ADDENDUM NO. 2

BID NO. 2838

**CLOVIS EAST HIGH SCHOOL CTE FARM AND FOOD PRODUCT FACILITY
CLOVIS UNIFIED SCHOOL DISTRICT
CLOVIS, CALIFORNIA**

G.A. PROJECT NO. 1739

S4.2

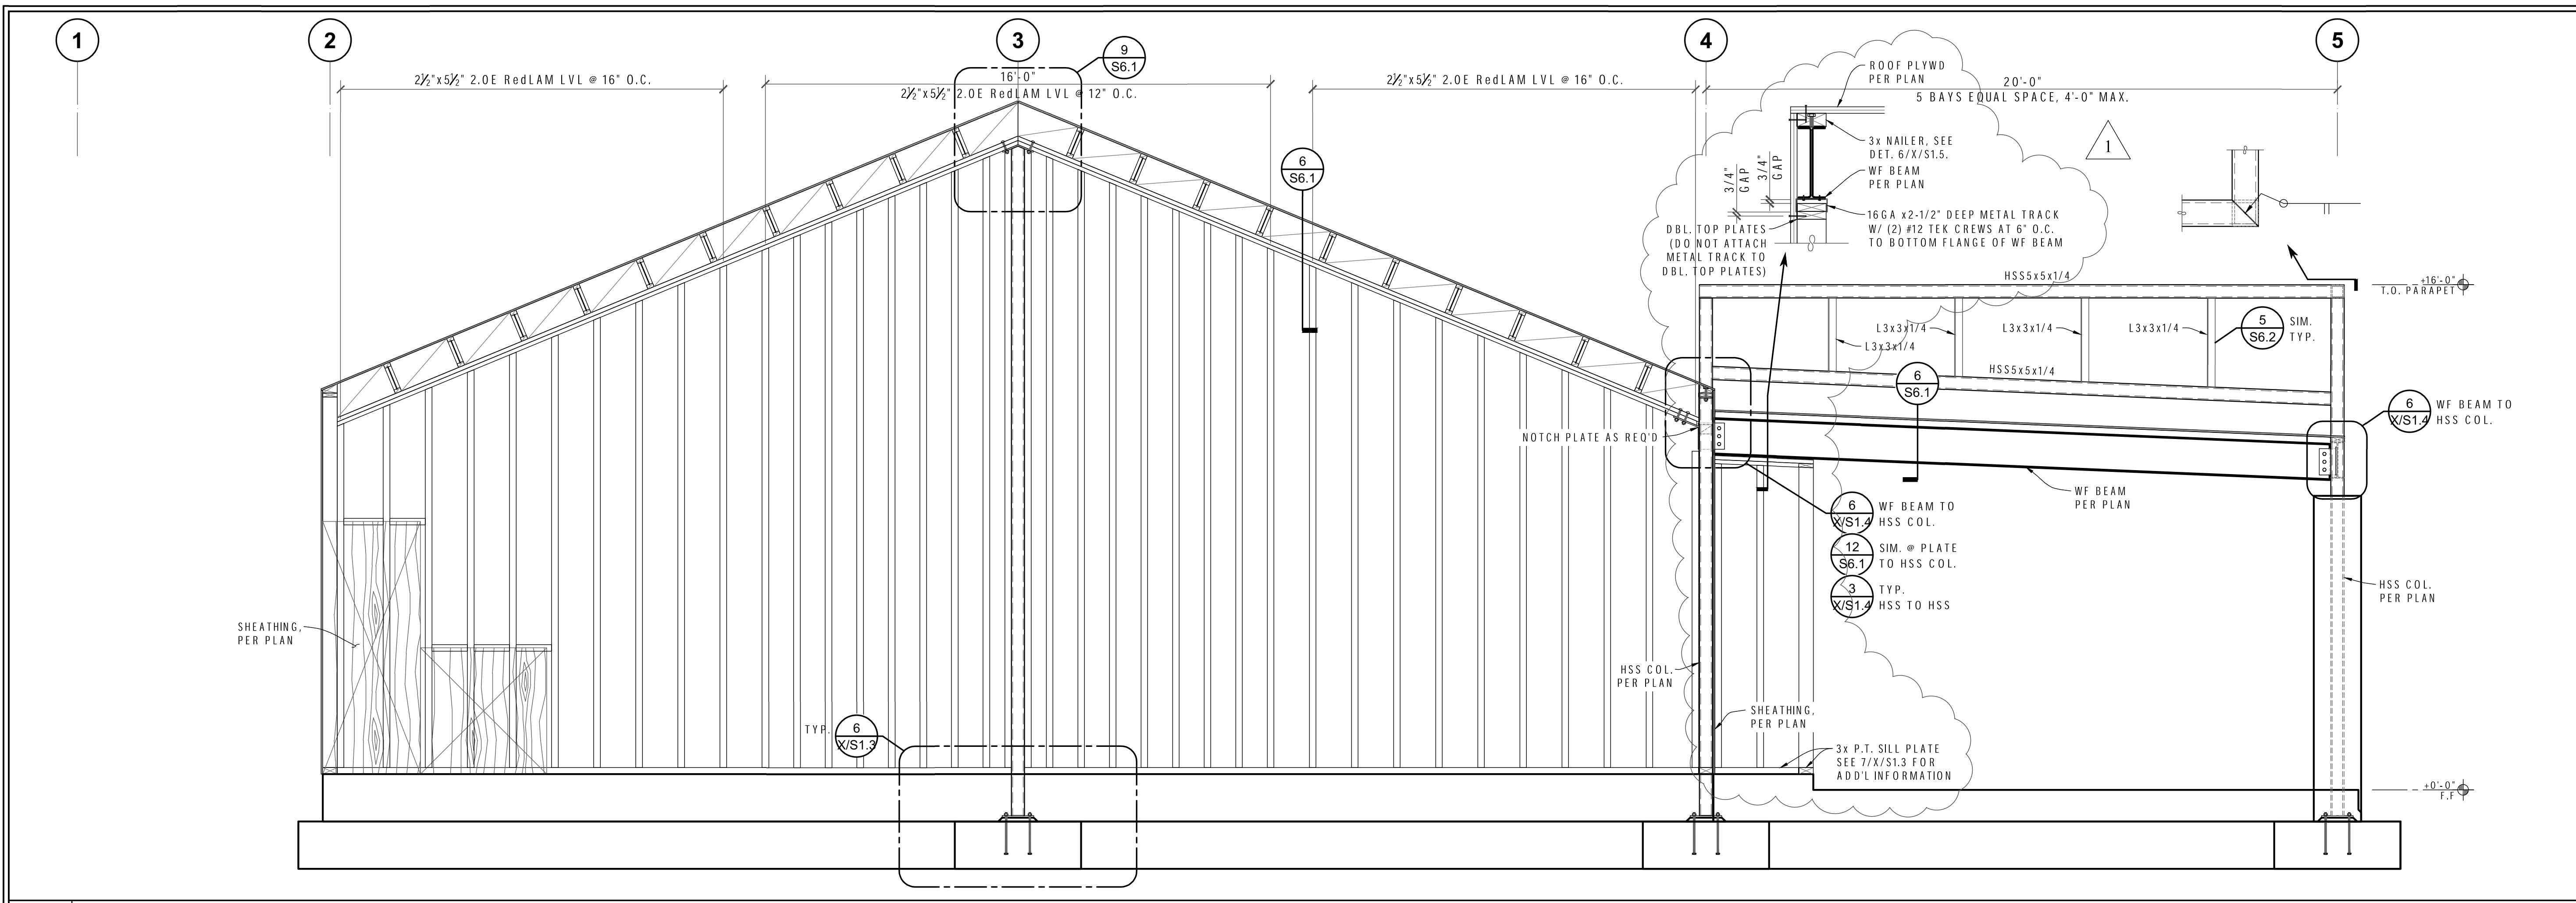
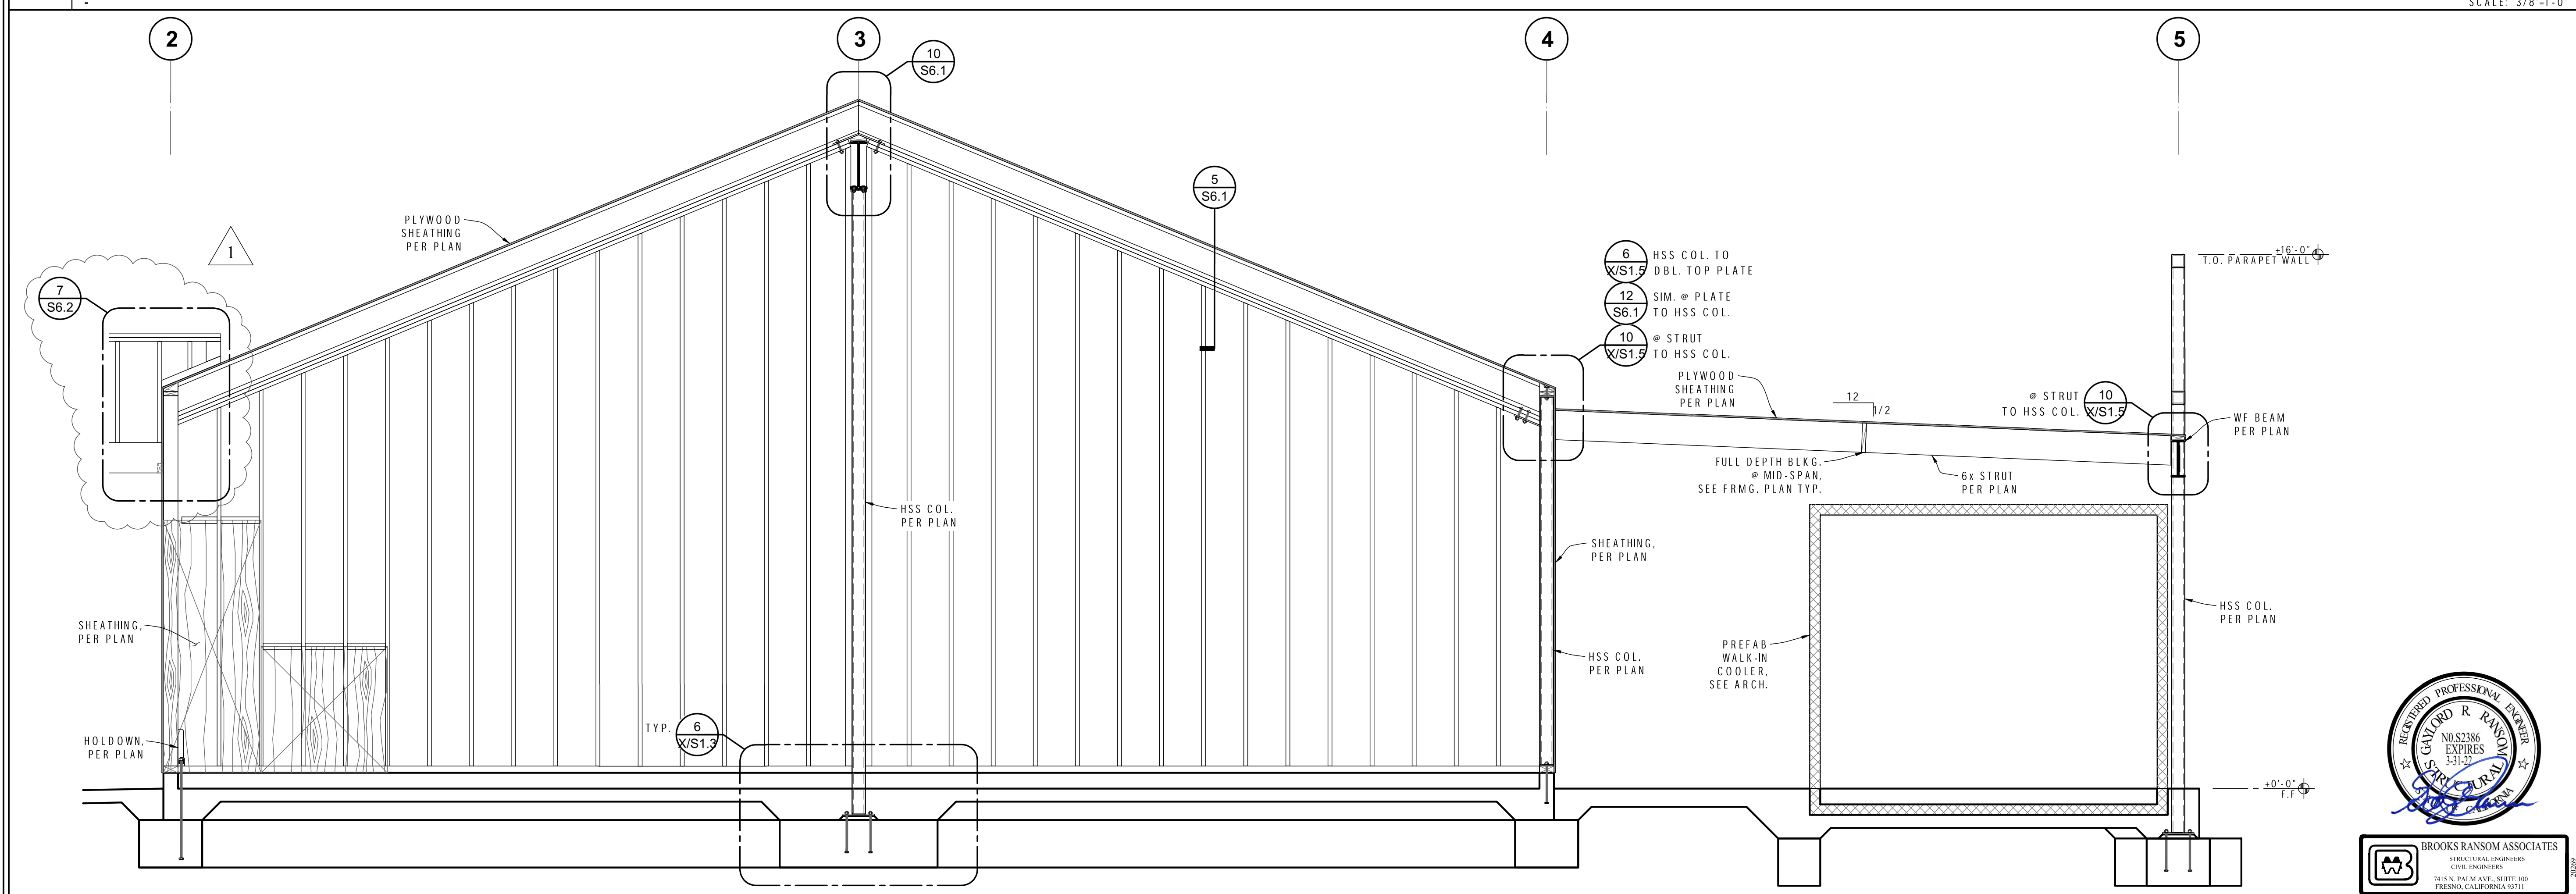
S4.2:

- 1.) Added and detailed structural wall on elevation 1.
- 2.) Revised and clarified wall on elevation 2.

S4.3

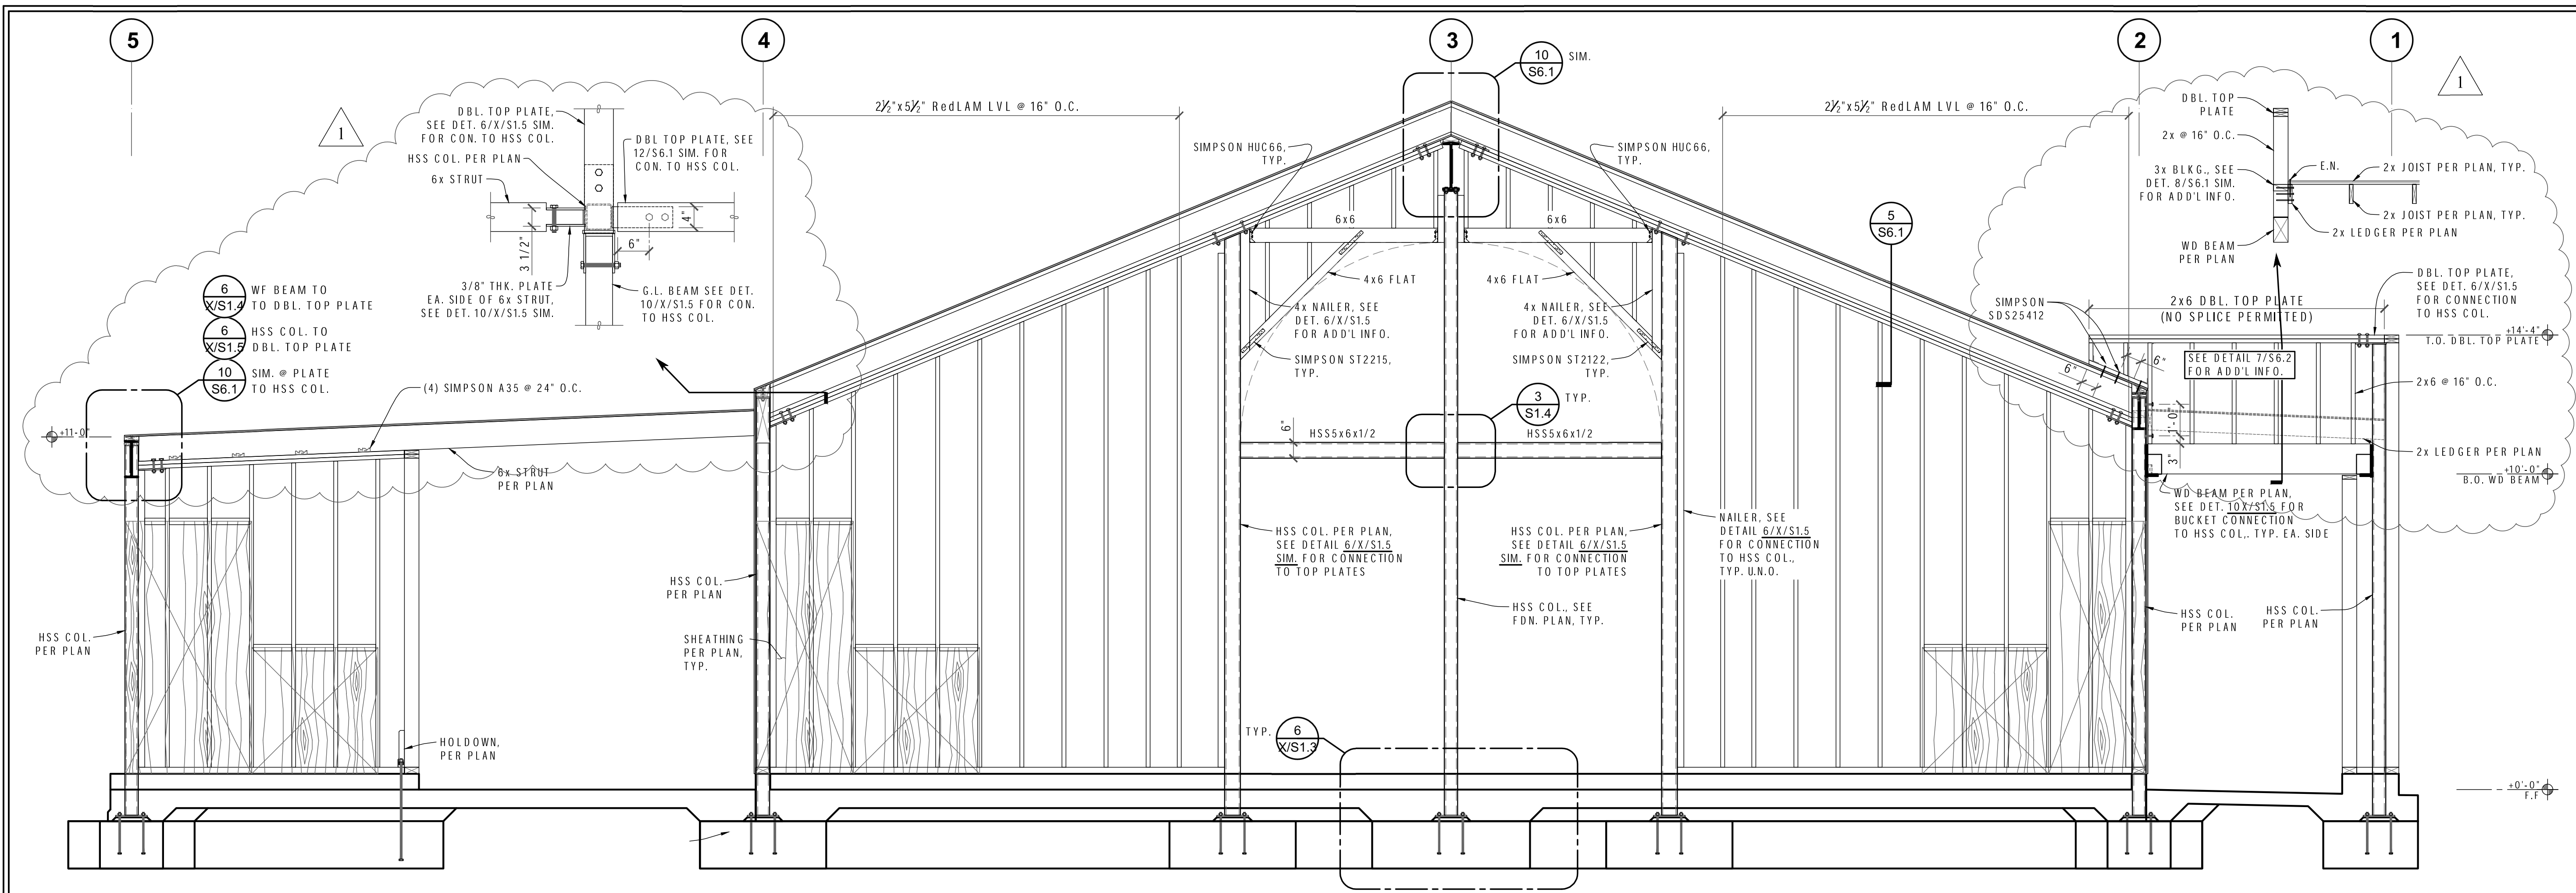
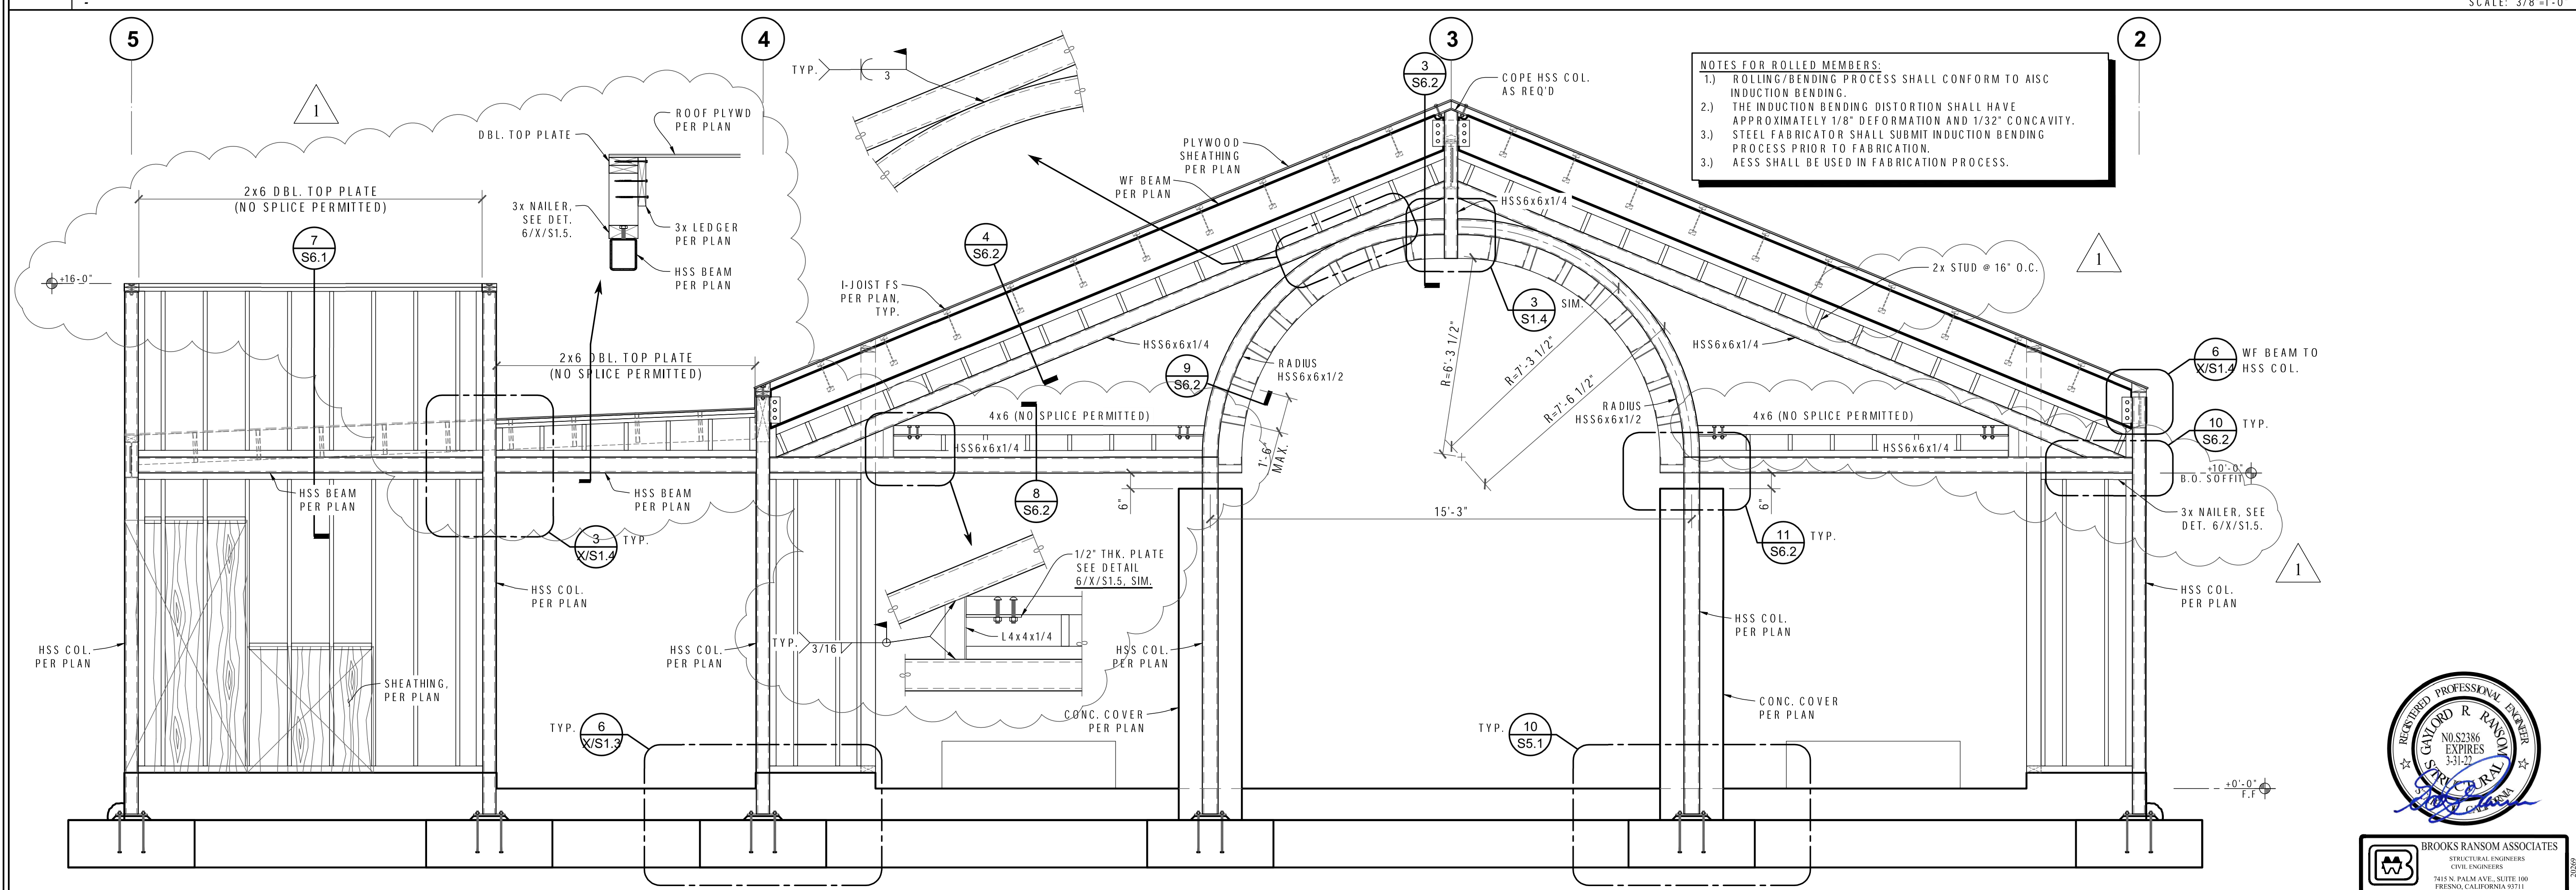
S4.3:

- 1.) Revised and clarified detail connections.
- 2.) Revised and clarified wall elevations and provided details.
